MILITARY SPECIFICATION

CIRCUIT BREAKERS, TRIP-FREE, AIRCRAFT,
GENERAL SPECIFICATION FOR

This amendment forms a part of MIL-C-5809G, dated 30 November 1987, and is approved for use by all Departments and Agencies of the Department of Defense.

MIL-C-5809G
AMENDMENT 1

FIGURE 2a. Sample fixture.

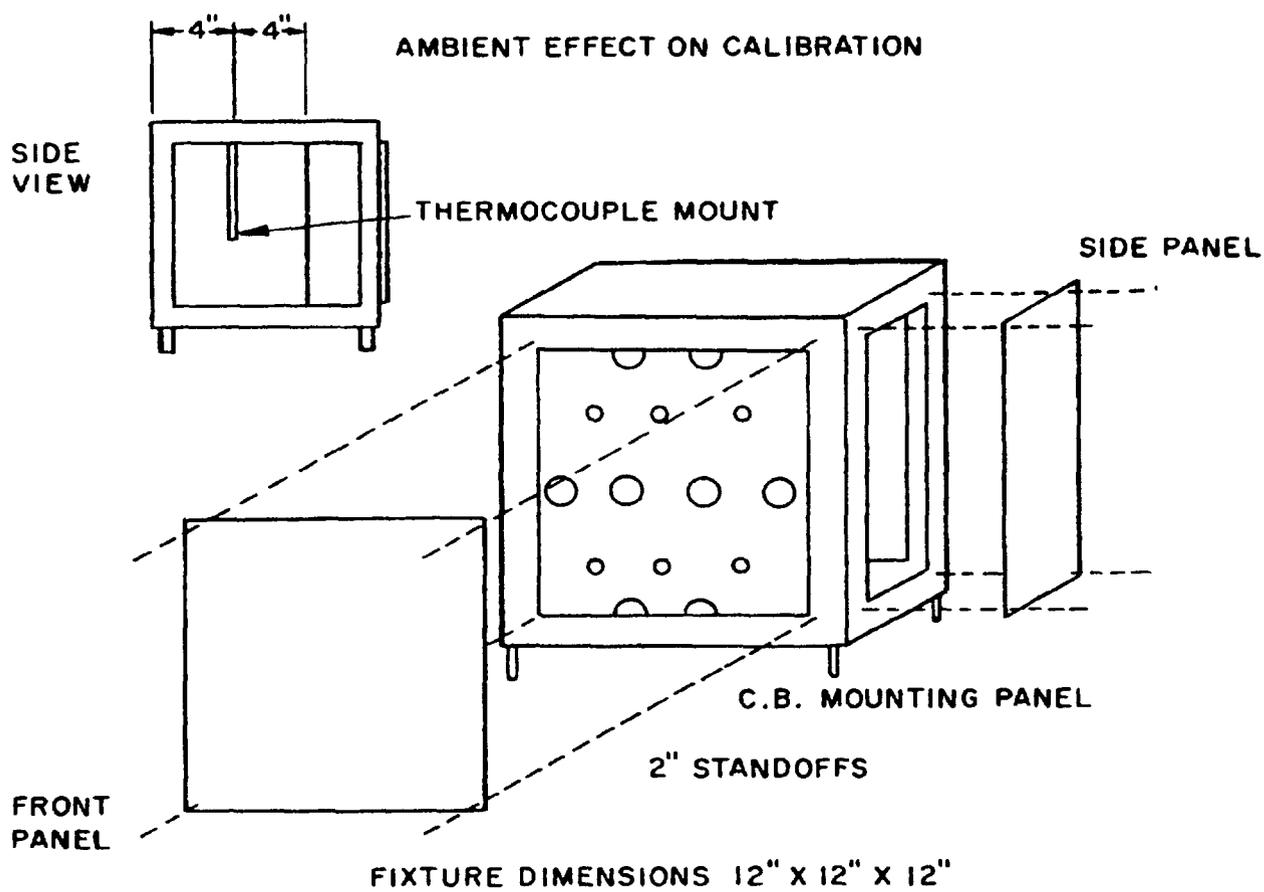
"4.7.7.5.1 Still air environment. Still air environment is the area surrounding the circuit breakers within a given chamber where any reduction in air velocity within the area of the circuit breakers would cause a maximum 2°C rise in temperature. The still air environment for temperature chambers 4 cubic feet and larger shall be obtained by using the fixture shown on figure 2a. Fixture dimensions are shown on figures 2b and 2c. The test fixture shall be placed in the temperature chamber so that the rear lead port of the fixture is facing away from the direct air flow created by the chamber circulating fan. A typical installation is shown on figure 2d. The distance of the rear lead port from the chamber wall shall be determined by first placing a fully loaded fixture beginning at 1 inch from the chamber wall and performing the minimum limit of ultimate trip test at both extremes of temperature. The temperature rise inside the fixture shall be monitored during the test. If the internal temperature exceeds the 2°C limit, the test shall be stopped and the fixture moved away from the chamber wall in small increments until the fixture internal temperature maintains the temperature gradient of +2°C within the area of the circuit breakers. During the performance of all calibration tests, a minimum of 18 inches of lead length shall be kept inside the chamber to cancel any of the effects of heat conduction from the circuit breakers through the leads. Room ambient tests shall be performed inside a temperature chamber set at 25°C. Alternate means of obtaining the still air environment must be approved by the Qualifying Activity.

For chambers that are less than 4 cubic feet in volume, the fixture dimensions stated for the chambers that are 4 cubic feet and larger can be modified and the number of circuit breakers that can be tested at one time can be reduced in order to meet the still air requirements."

After 4.7.7.5.1, insert the attached figures 2a through 2d.
